STATE OF VERMONT
AGENCY OF TRANSPORTATION

PROPOSED IMPROVEMENT
BRIDGE PROJECT

ROUTE NO: TH 2, FAS 105, (MAJOR COLLECTOR) BRIDGE #32

RECORD PLANS

TYPICAL BRIDGE SECTION
(40:1 SCALE)

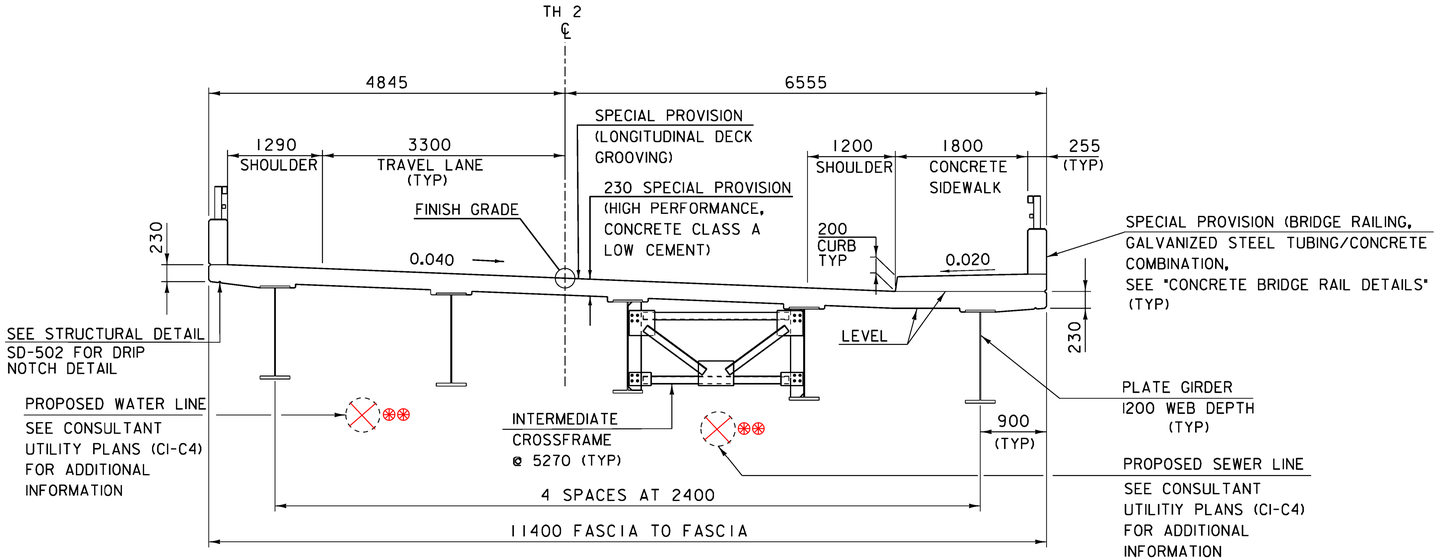
⊛⊛ TOWN DID NOT WANT THESE (TOO LOW) AND CHANGES WERE MADE. SEE CHANGE ORDER #4, DATED 10/17/13

FILE NAME: 89J088/STR/s89J088utilbdr.dgn
PROJECT LEADER: J. LACROIX
DESIGNED BY: W. PELLETIER
DRAINAGE LAYOUT SHEET 1
PLOT DATE: 07-MAR-2012
DRAWN BY: G. ROKES
CHECKED BY: W. PELLETIER
SHEET 20 OF 90

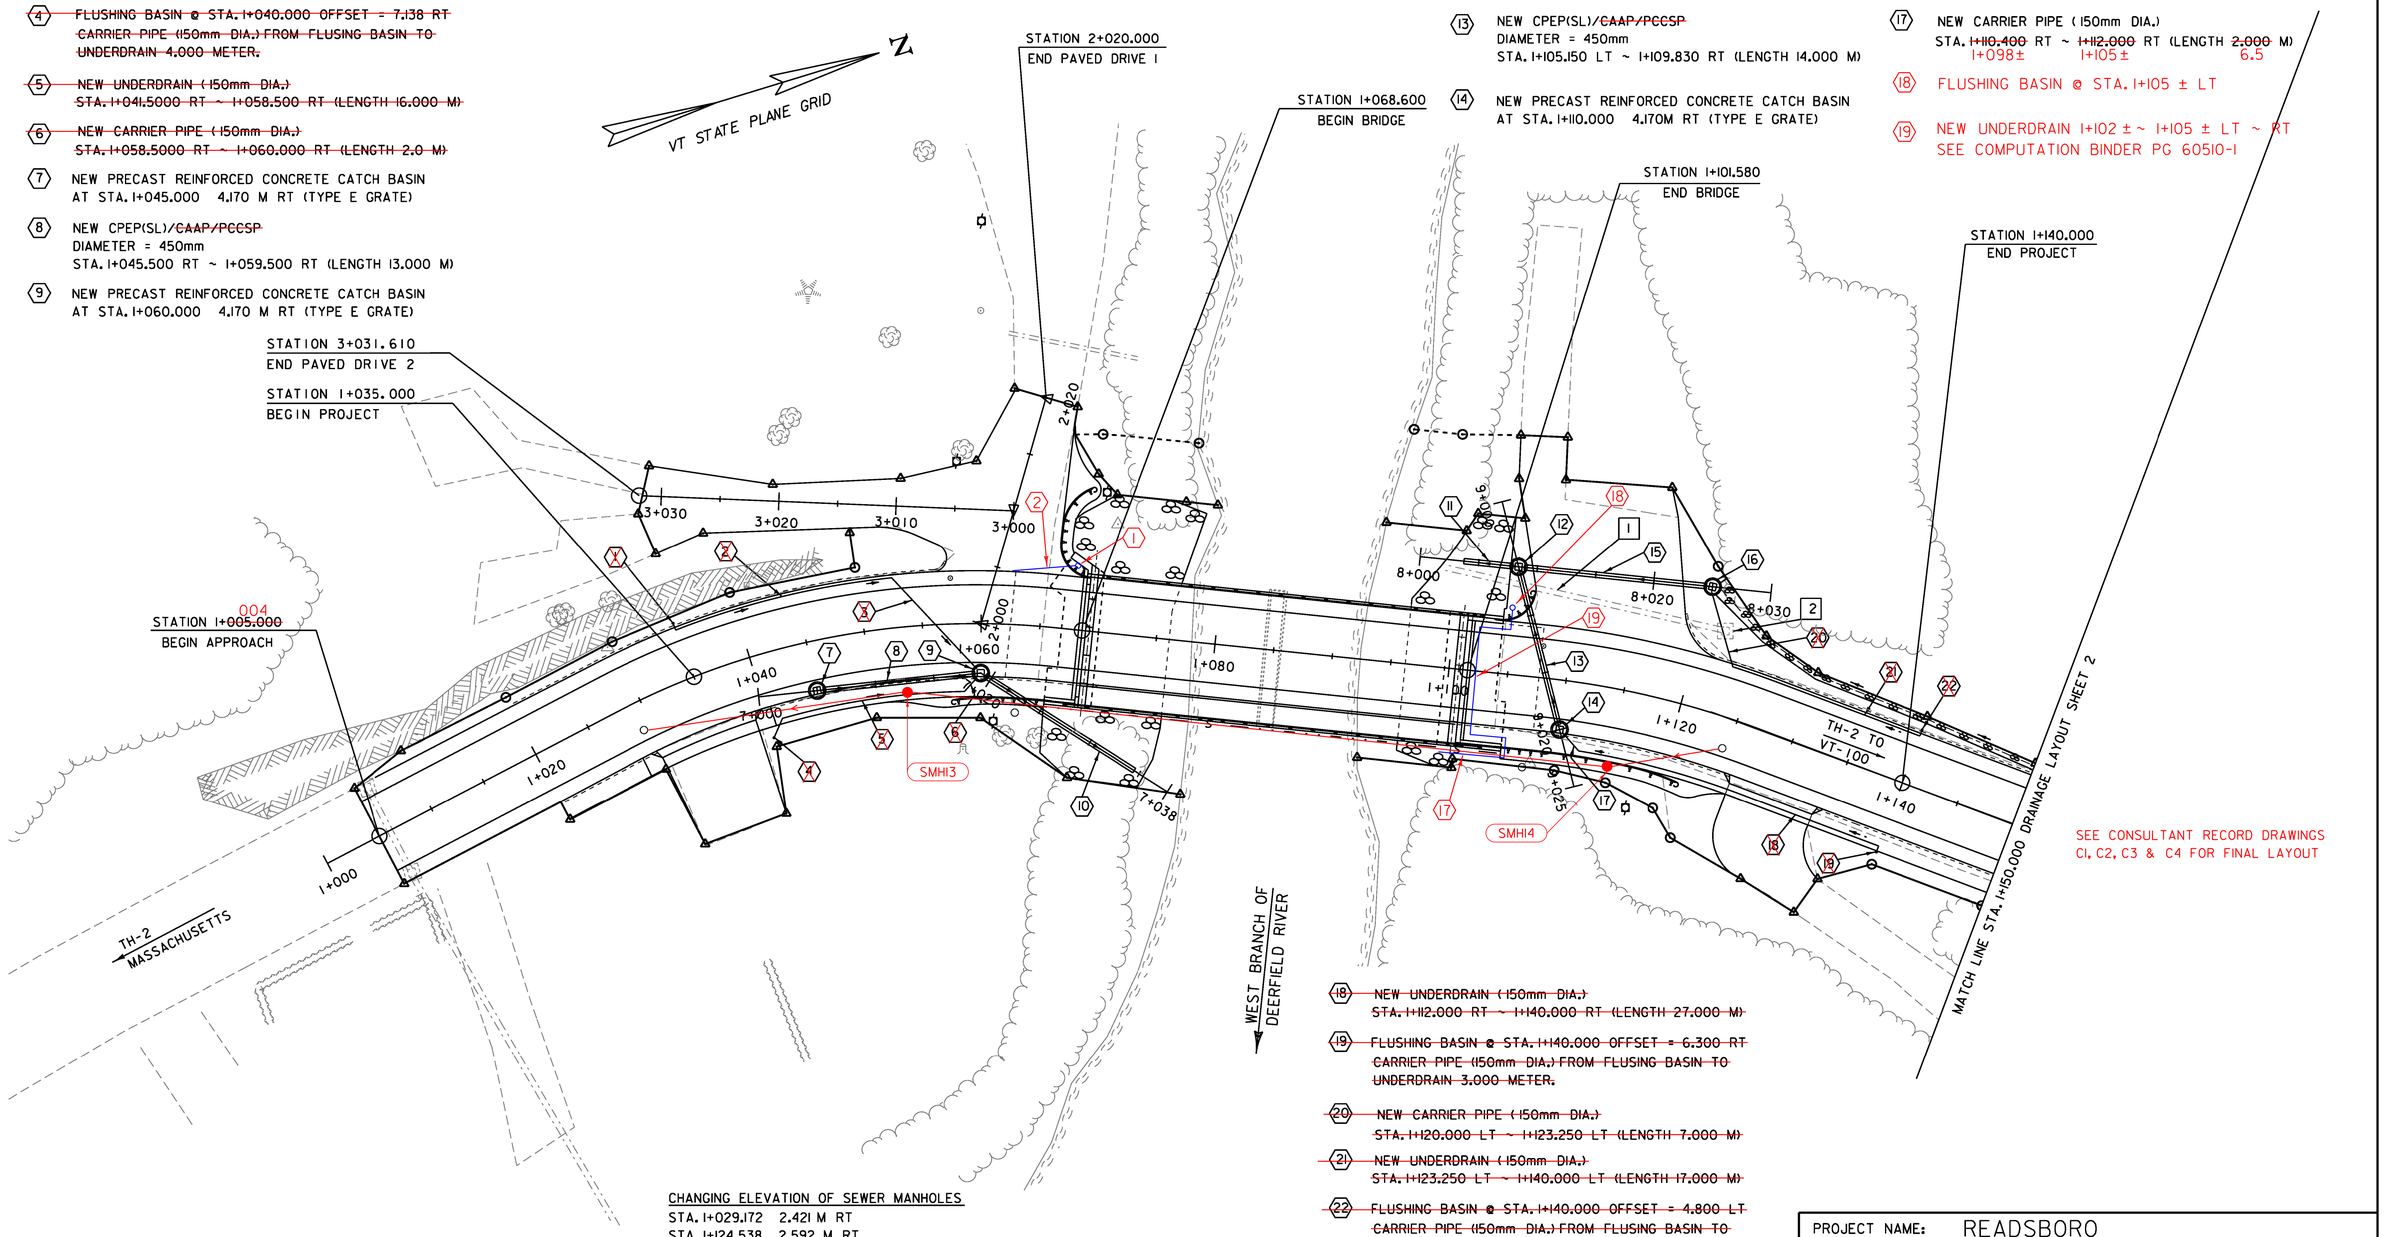
10. NEW CPEP(SL)/~~CAAP/PCCSP~~ DIAMETER = 450mm STA. I+060.400 RT ~ I+073.400 RT (LENGTH 15.000 M)
11. NEW CPEP(SL)/~~CAAP/PCCSP~~ DIAMETER = 450mm STA. I+100.333 LT ~ I+104.533 LT (LENGTH 5.000 M)
12. NEW PRECAST REINFORCED CONCRETE CATCH BASIN AT STA. I+105.000 9.185 M LT (TYPE E GRATE)
13. NEW CPEP(SL)/~~CAAP/PCCSP~~ DIAMETER = 450mm STA. I+105.150 LT ~ I+109.830 RT (LENGTH 14.000 M)
14. NEW PRECAST REINFORCED CONCRETE CATCH BASIN AT STA. I+110.000 4.170M RT (TYPE E GRATE)
15. NEW CPEP(SL)/CAAP/PCCSP DIAMETER = 450mm STA. I+105.493 LT ~ I+119.548 LT (LENGTH 16.000 M)
16. NEW PRECAST REINFORCED CONCRETE CATCH BASIN AT STA. I+120.000 10.309 M LT (TYPE E GRATE)
17. NEW CARRIER PIPE (150mm DIA.) STA. ~~I+110.400~~ I+098± RT ~ ~~I+112.000~~ I+105± RT (LENGTH ~~2.000~~ 6.5 M)
18. FLUSHING BASIN @ STA. I+105 ± LT
19. NEW UNDERDRAIN I+102 ± ~ I+105 ± LT ~ RT SEE COMPUTATION BINDER PG 6051O-1

CHANGING ELEVATION OF SEWER MANHOLES
STA. I+029.172 2.421 M RT
STA. I+124.538 2.592 M RT

SEE CONSULTANT RECORD DRAWINGS C1, C2, C3 & C4 FOR FINAL LAYOUT

ABUTMENT #1 FOOTING REINFORCING PLAN

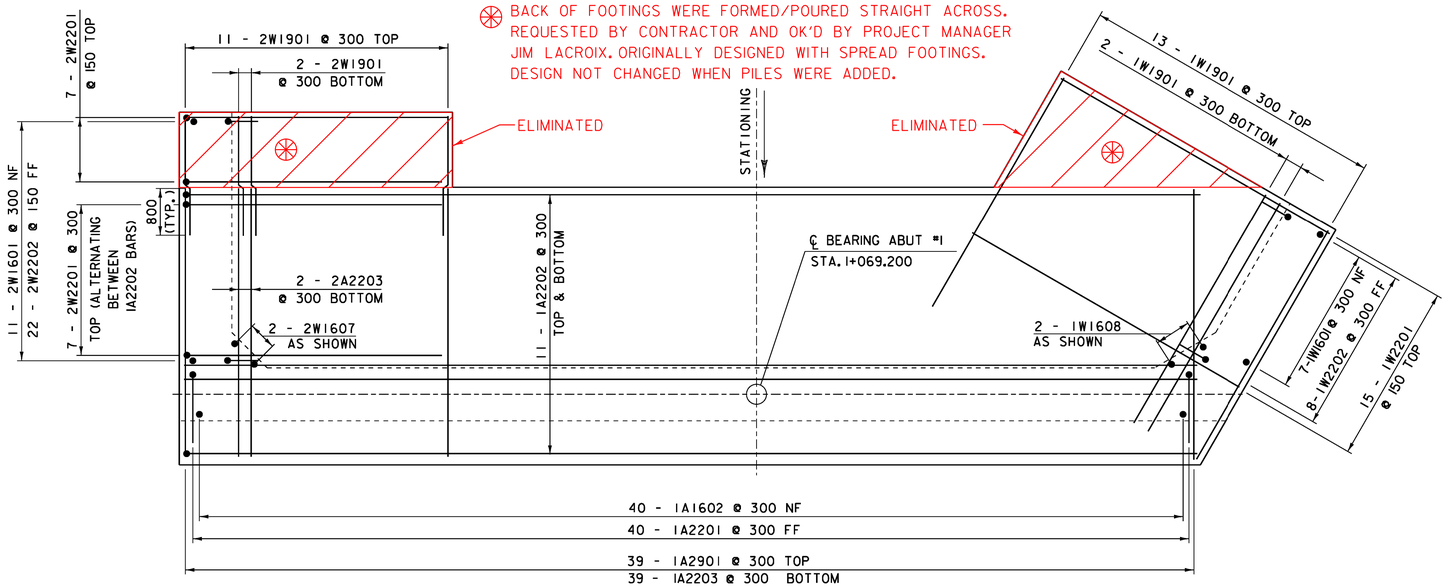
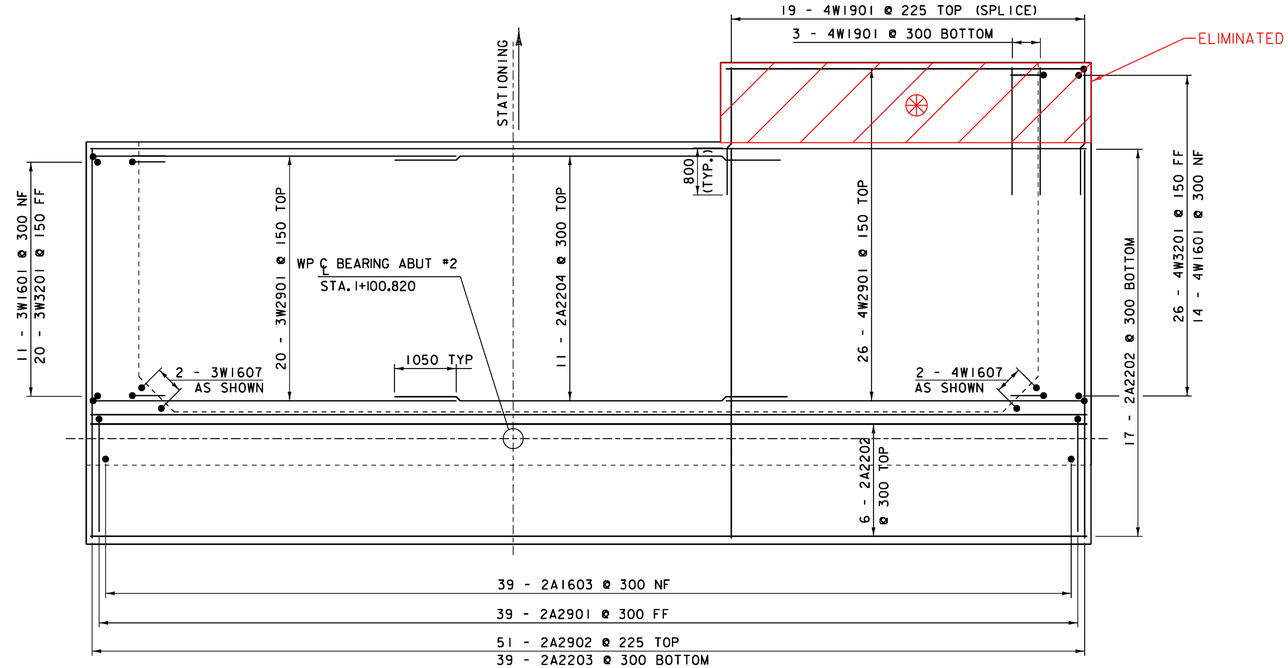
PORTION OF FOOTINGS ELIMINATED DUE TO LACK OF NEED, PILES USED! SEE SHEET 49

SEE SHEET 49 FOR PILE LOCATIONS.

ABUTMENT #1 PLAN

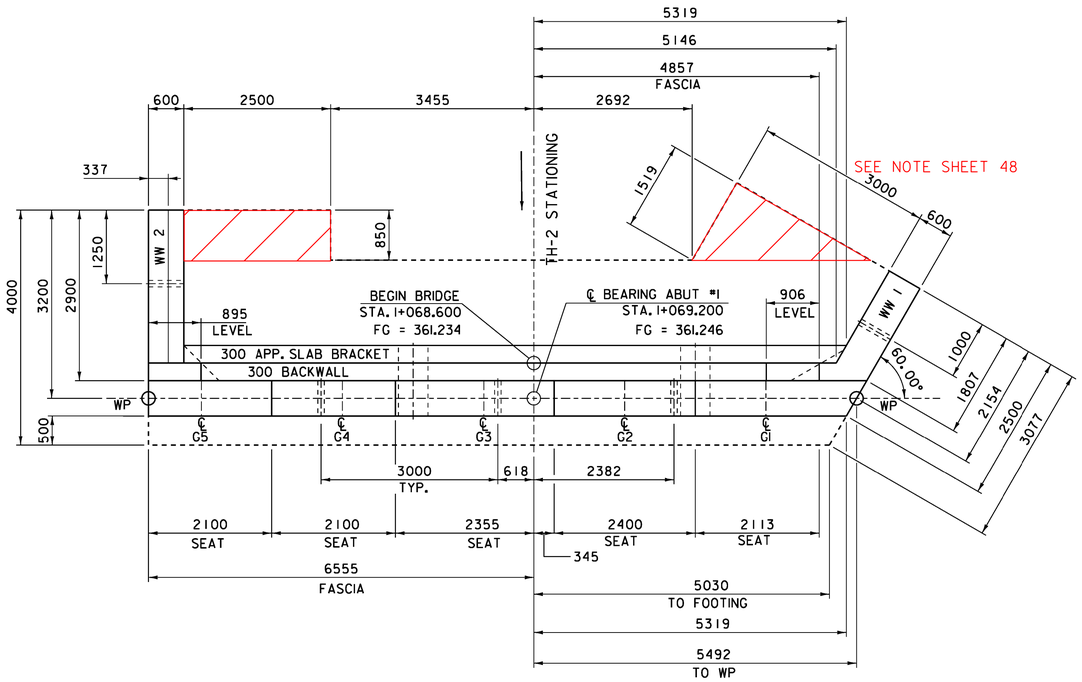
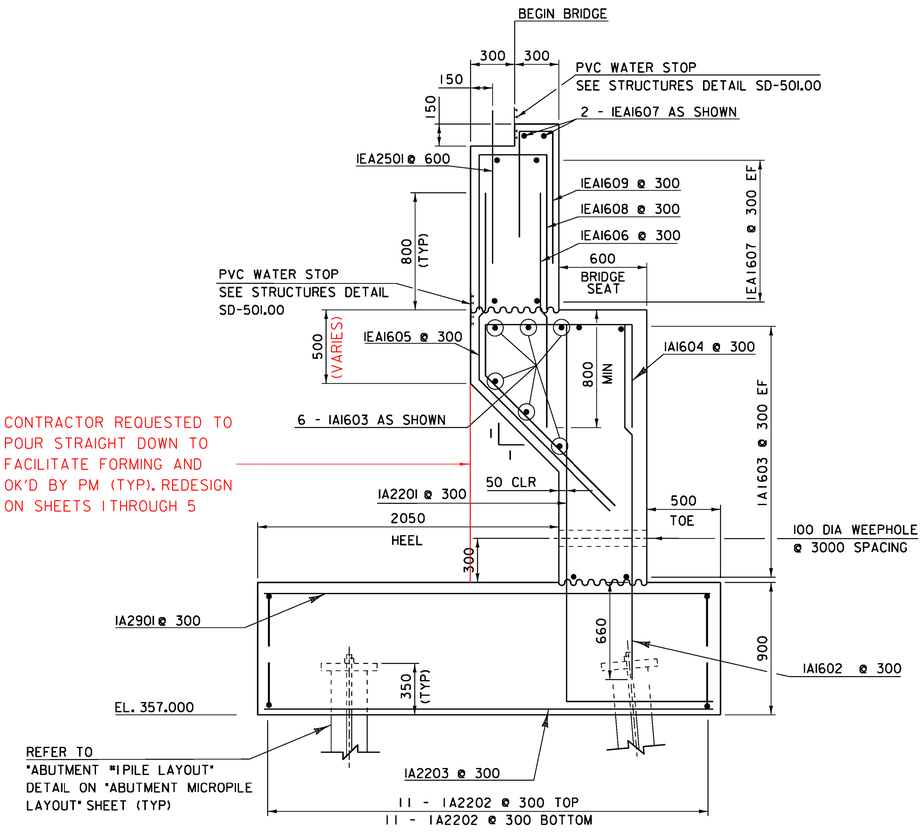
CONTRACTOR REQUESTED TO POUR STRAIGHT DOWN TO FACILITATE FORMING AND OK'D BY PM (TYP). REDESIGN ON SHEETS 1 THROUGH 5

SEE REVISED PAGES # 1~5

APPROACH SLAB #1

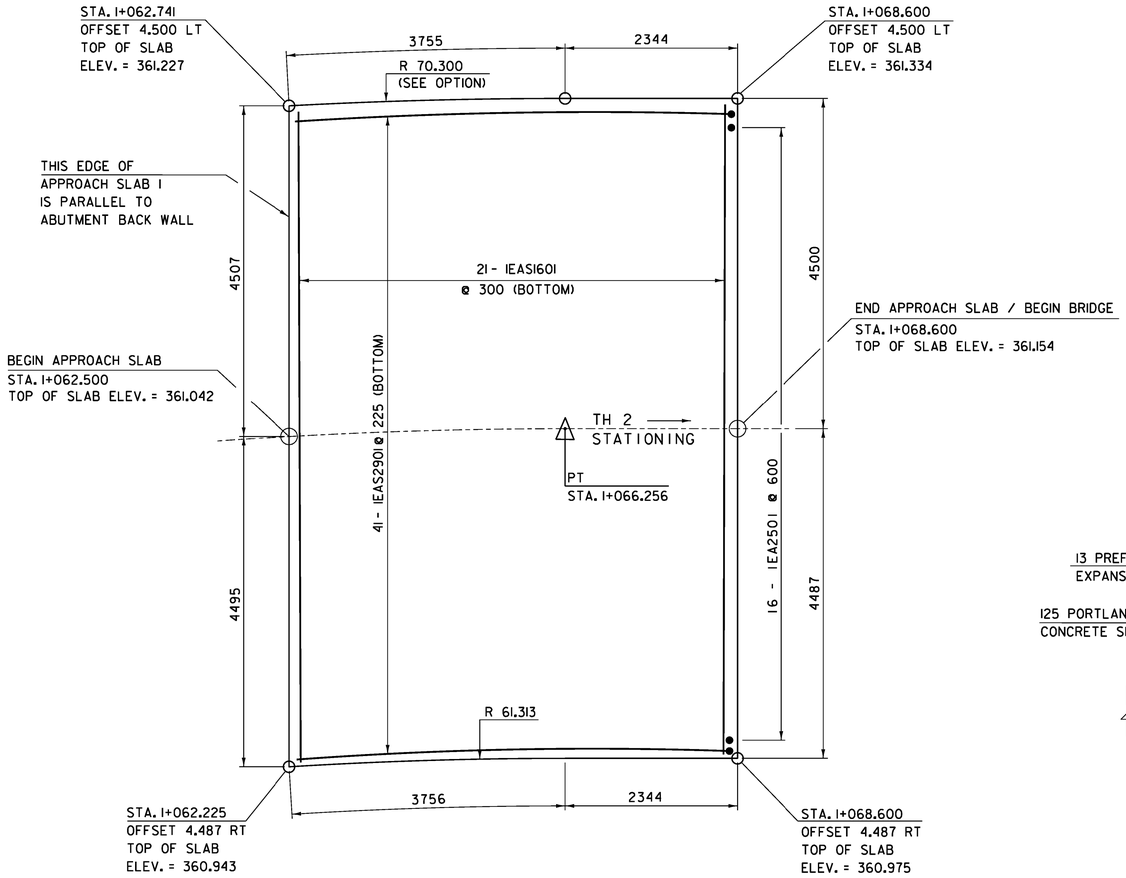
CONTRACTOR OPTION:
APPROACH SLAB RADIUS MAY BE APPROXIMATED BY STRAIGHT LINE ON THIS SIDE. NO CHANGE TO CONCRETE QUANTITIES WILL BE ALLOWED.

FILE NAME: 89J088/STR/sj088xs.dgn
PROJECT LEADER: J. LACROIX
DESIGNED BY: W. PELLETIER
CHANNEL CROSS SECTIONS SHEET 1

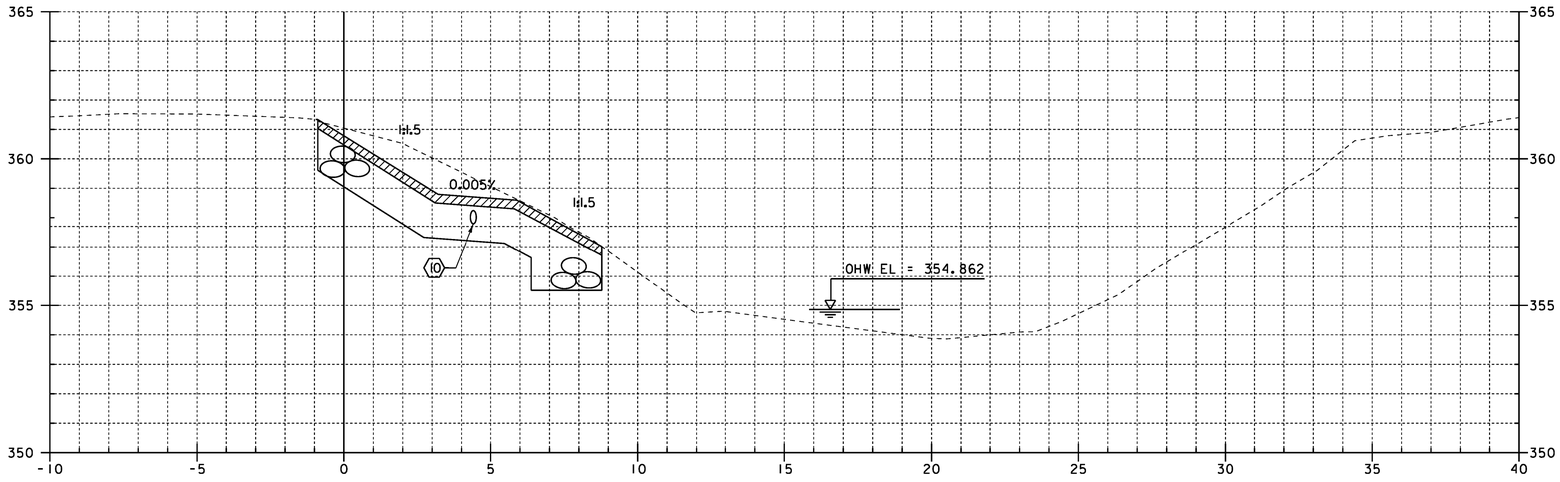
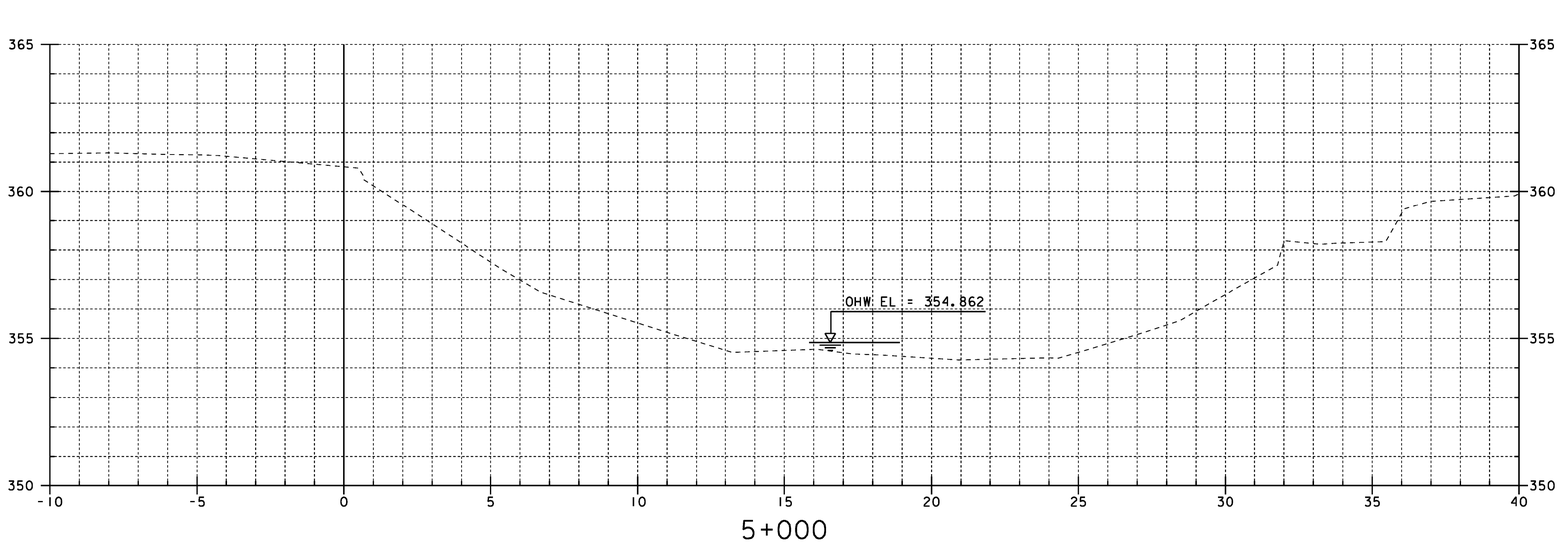
SEE NEW CHANNEL CROSS SECTIONS
